Access Compliance Report

Public Rights-of-Way

(Curb Ramps)

Intersection ID: 10019937	Main Street: ARDREY_KELL_RD	Cross Street: N/A	Location: NW
ADA ID: 6E6A10E77CCF	Ramp Type: Perp	Initial Pass/Fail: Fail	Overall Compliance: No
Severity Score: 1.25			
Codes/Mitigation Info/Possible Solution		Field Measurements/Component Compliance

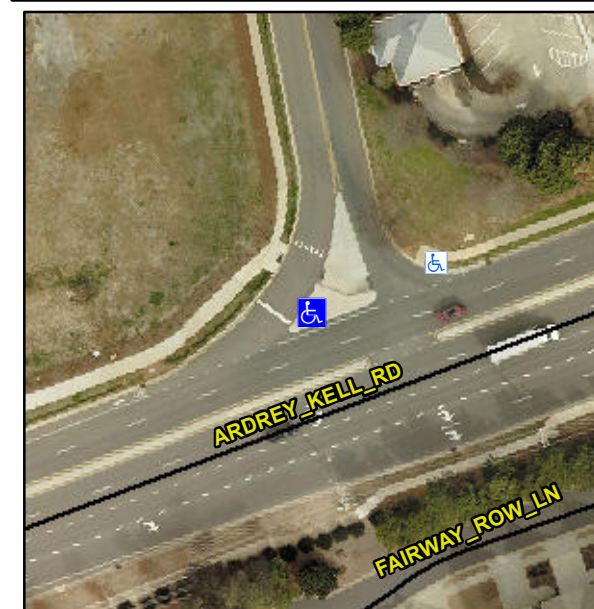
R304.5.3

Compliance	Description	Data	Compliance	Description	Data
N/A	Ramp Length (in)	61.0	Yes	Ramp Slope (%)	6.1
Yes	Ramp Width (in)	60.0	No	Ramp XSlope (%)	2.3
N/A	Flare Type LT	N/A	N/A	Flare Type RT	N/A
N/A	Flare Slope LT (%)	N/A	N/A	Flare Slope RT (%)	N/A
N/A	Flare Traversable LT?	N/A	N/A	Flare Traversable RT?	N/A
N/A	Landing Length (in)	N/A	N/A	DWS Provided?	N/A
N/A	Landing Width (in)	N/A	N/A	DWS Contrast?	N/A
N/A	Landing Slope (%)	N/A	N/A	DWS Length (in)	N/A
N/A	Landing X Slope (%)	N/A	N/A	DWS Full Width?	N/A
N/A	Landing Curb? (Y/N)	N/A	N/A	DWS Offset (in)	N/A
N/A	Shared Landing?	N/A			
N/A	Gutter Ponding?	N/A	N/A	Gutter Slope (%)	N/A
N/A	Gutter Lip Ht (in)	N/A	N/A	Gutter X Slope (%)	N/A
N/A	Painted X Walk1?	No	N/A	Painted X Walk2?	N/A
	X Walk 1 Direction	To E		X Walk 2 Direction	N/A
N/A	X Walk 1 Width (in)	N/A	N/A	X Walk 2 Width (in)	N/A
	X Walk 1 Slope (%)	3.7		X Walk 2 Slope (%)	N/A
	X Walk 1 X Slope (%)	3.6		X Walk 2 X Slope (%)	N/A

Remove & Replace Entire Ramp.
